CALIFORNIA COASTAL COMMISSION

**STAFF REPORT
PERMIT AMENDMENT**

Application number **4-83-490-A1, Cliffs Hotel Revetment & Dewatering Plan**

Figure 4-3 Long-term Loss of Beach Area with a Fixed Back Beach.

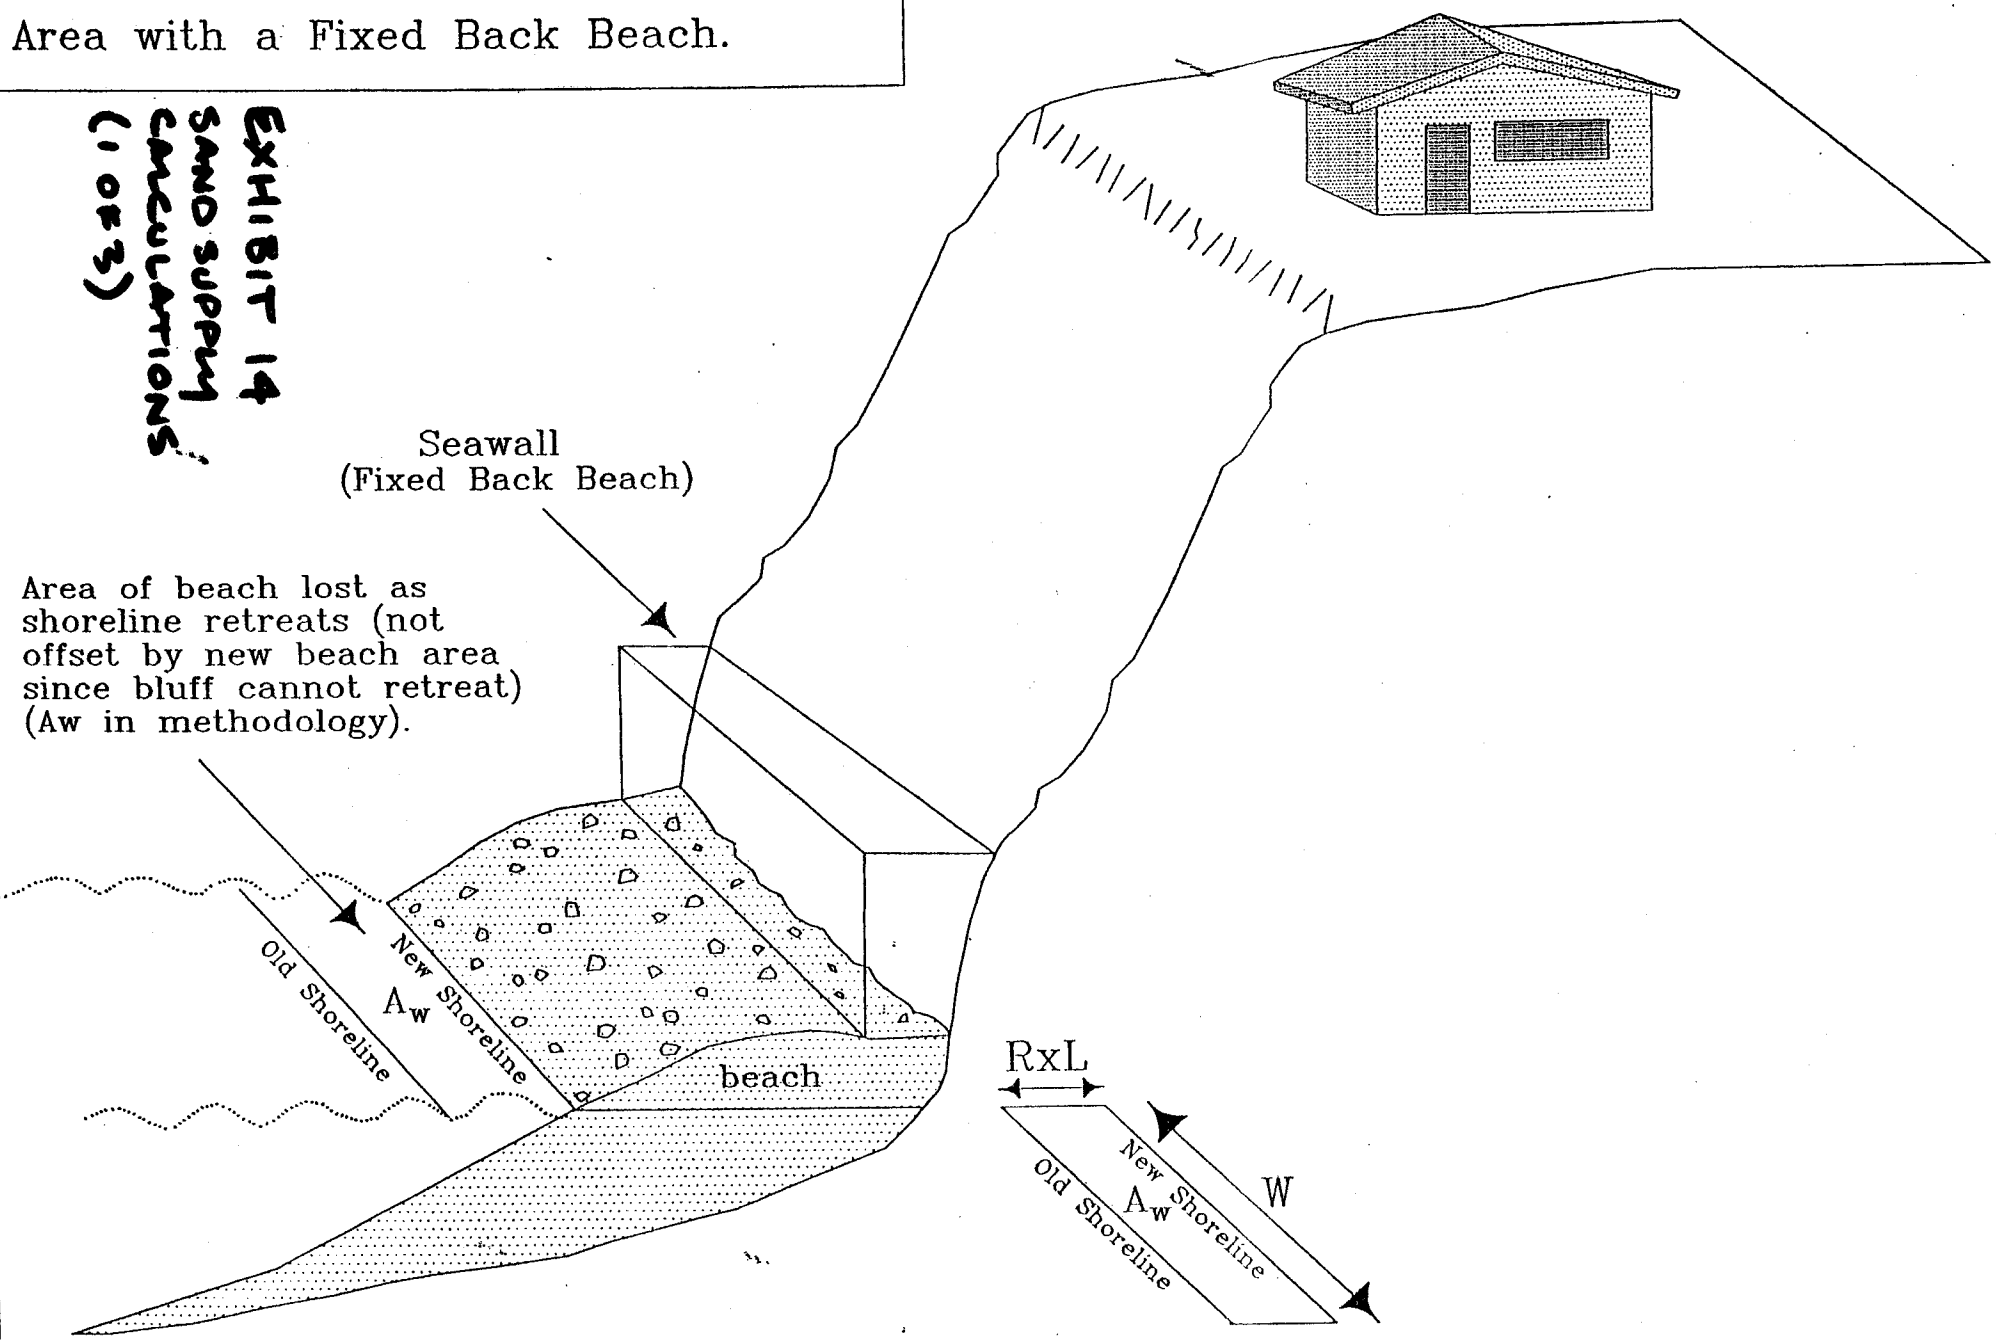
Page 1 of Exhibit 14 generally illustrates this calculation. Since the actual amount of long-term erosion cannot be predicted precisely, erosion is approximated by the long-term average annual erosion rate times the number of years that the back beach or bluff will be fixed. The width of the property which would be fixed can be determined from the proposed project design (approximately 435 linear feet of shoreline according to the proposed plans). The erosion rate has been estimated at 4-feet per year by the Applicant's geotechnical consultant. Although the projected lifetime of the proposed revetment structure has not been determined in this case, if the structure were in place it would result in an annual long term loss of beach at the site due to fixing the back beach location as follows:

Figure 4-4 Material Added to Littoral System from Natural Bluff Erosion.

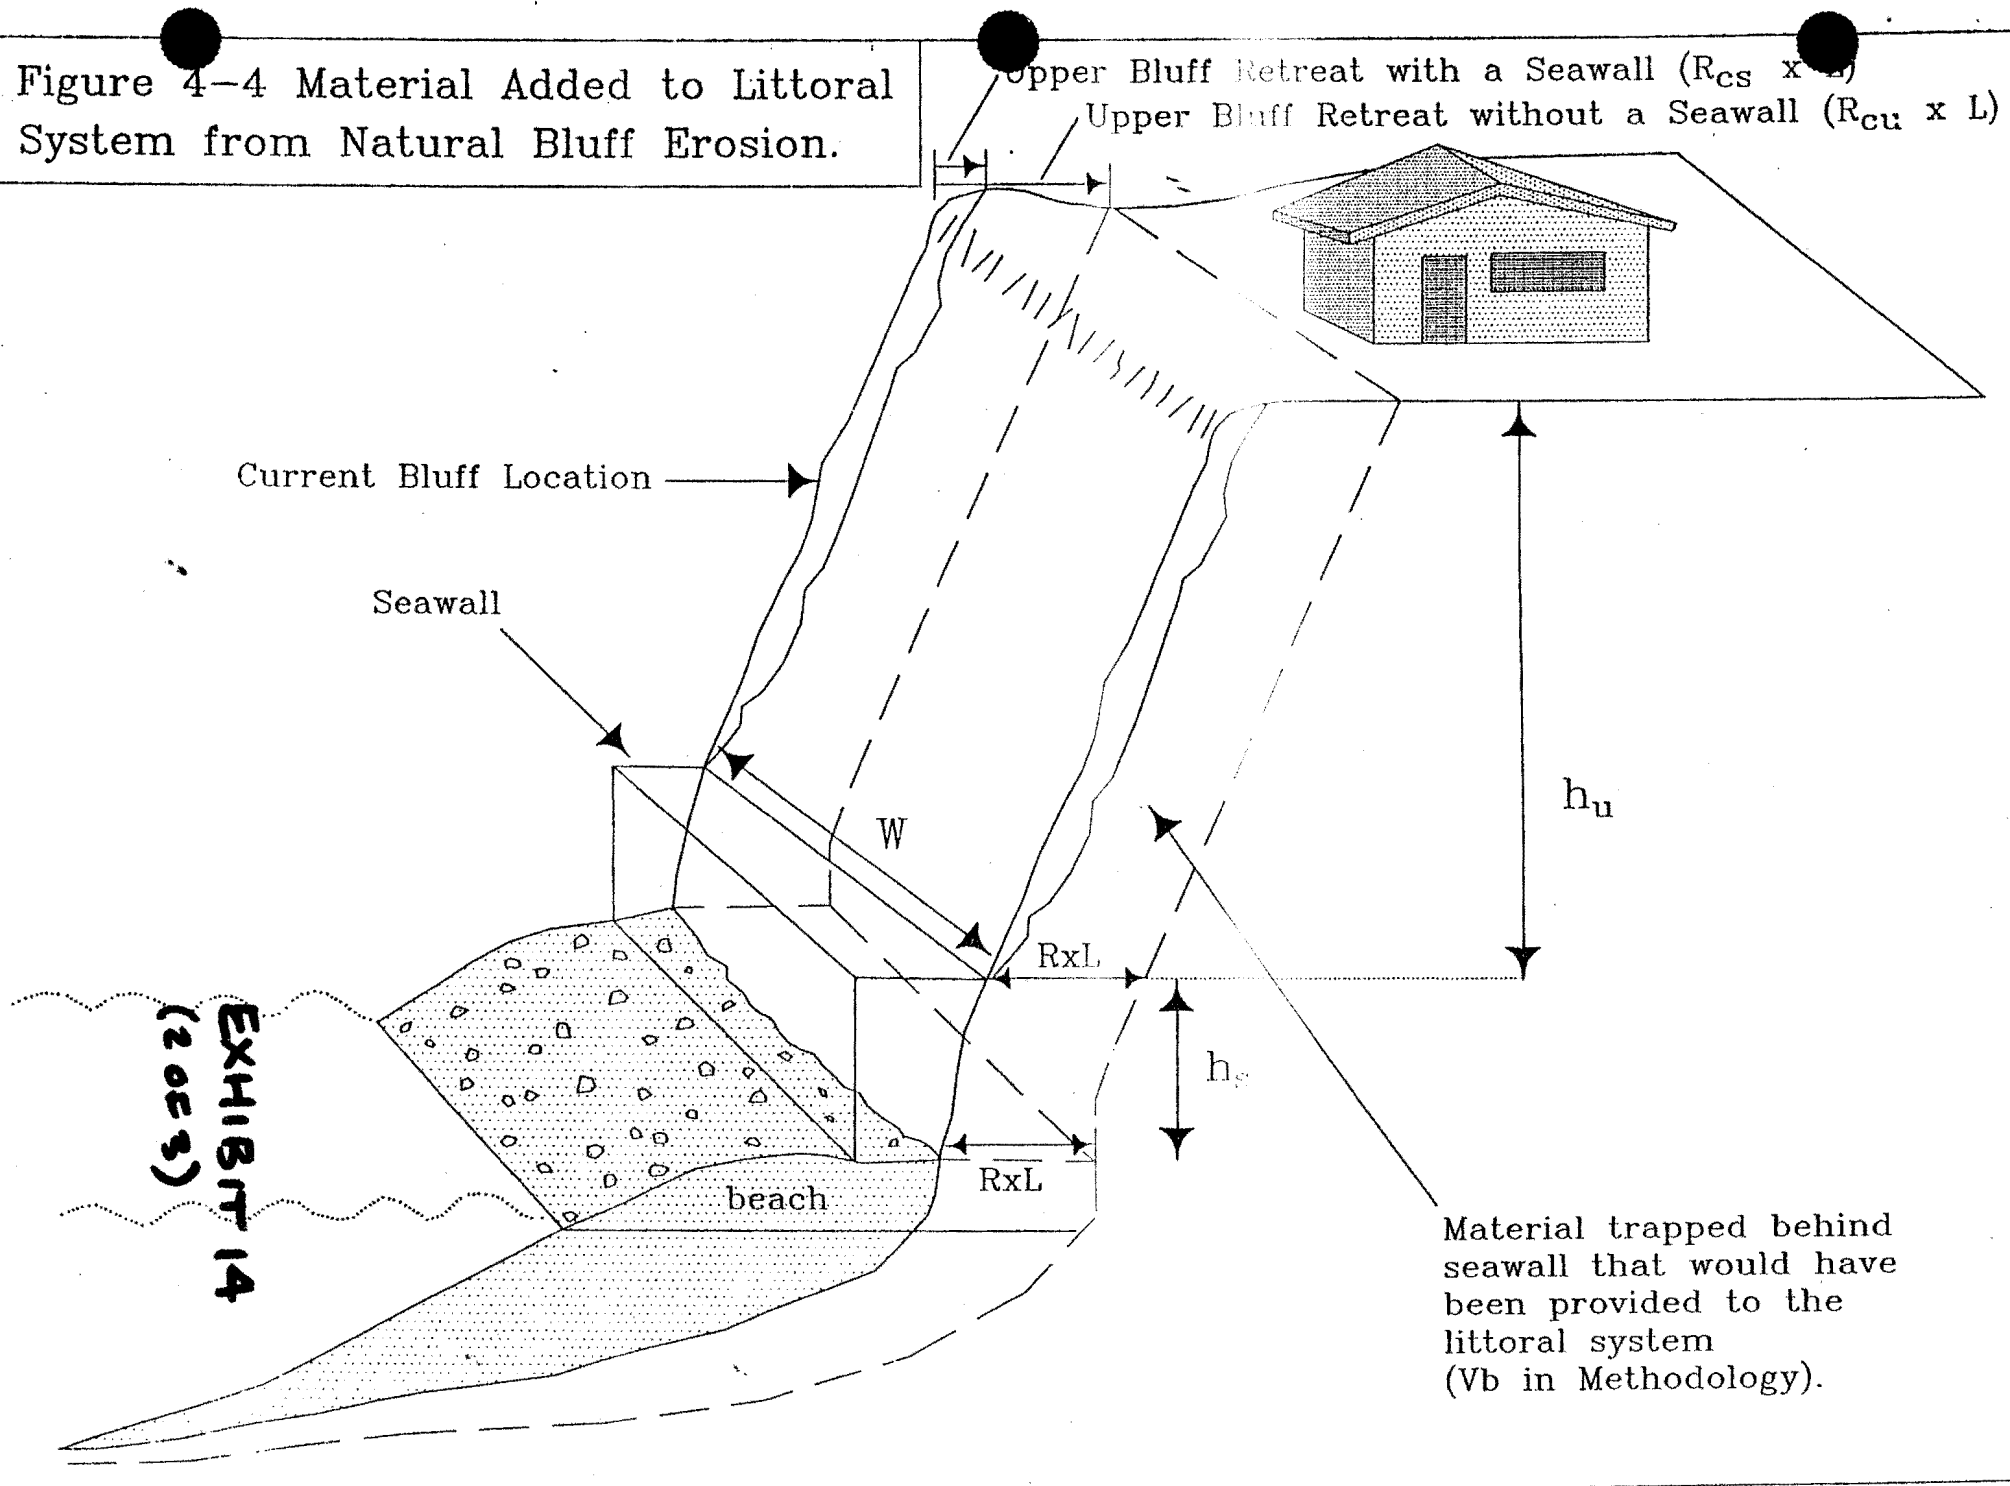
Volume of sand denied the beach by the protective device (V_b) is equal to the percentage of sand in the bluff material (S) times the total width of the protected property (W) times the area between the solid and dotted lines in Page 2 of Exhibit 14 directly landward of the device [$R \times h_s$], plus the area between the solid and dotted area above the device [$1/2h_u \times (R + (R_{cu} - R_{cs}))$]. Since the dimensions and retreat rates are usually given in feet and volume of sand is usually given in cubic yards, the total volume of sand must be divided by 27 to provide this volume in cubic yards, rather than cubic feet. This can be expressed by the following equation:
